In re Appln. Of: Barry T. Brinks, et al.
Application No.: 10/796,811

High Recovery Sonic Gas Valve
Annotated Marked-Up Drawings

Application No. 10/796,811 Reply to Office Action of June 14, 2005
Attorney Docket No. 502724, Telephone (815) 484-1900

FIG. 6

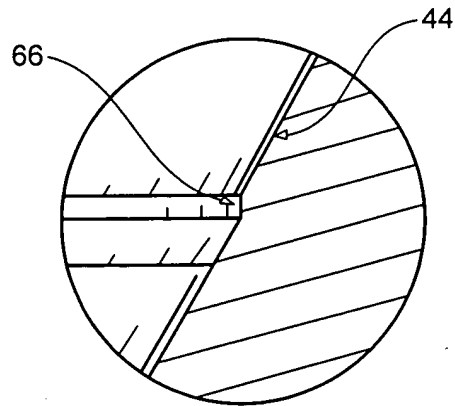
The Examiner objected to the drawing figures under 37 C.F.R. § 1.83(a). In particular, the Examiner indicated that “the inner diameter of the initial start position is smaller than the inner diameter of the throat nozzle, the initial start position being downstream of the throat nozzle” in Claims 3 and 32 must be shown in the drawings. The Examiner has also indicated that the same language as recited in Claim 43 must be shown in the drawings. It is assumed that the Examiner meant Claim 38, and not Claim 43, and this response to the Examiner’s objection is based on this assumption.

FIG. 6 has been amended to add reference 29 to indicate that an inner diameter of the initial start position is downstream of the nozzle throat. As recited in each of Claims 3, 32, and 38, an inner diameter 29 of the initial start position, which is downstream of the nozzle throat and has the smaller diameter, and an inner diameter of the nozzle throat are now both clearly shown in FIG. 6. Therefore, the Examiner is requested to approve the accompanying replacement drawings. No new matter has been entered or added.

A replacement sheet of drawings, which includes changes to FIG. 6, has been attached to this Amendment and has been labeled "Replacement Sheet". See the Remarks section for a discussion on the changes.

A marked up copy of the drawings highlighting the changes to FIG. 6 has also been attached to this Amendment for the convenience of the Examiner and has been labeled "Annotated Marked-up Drawings".
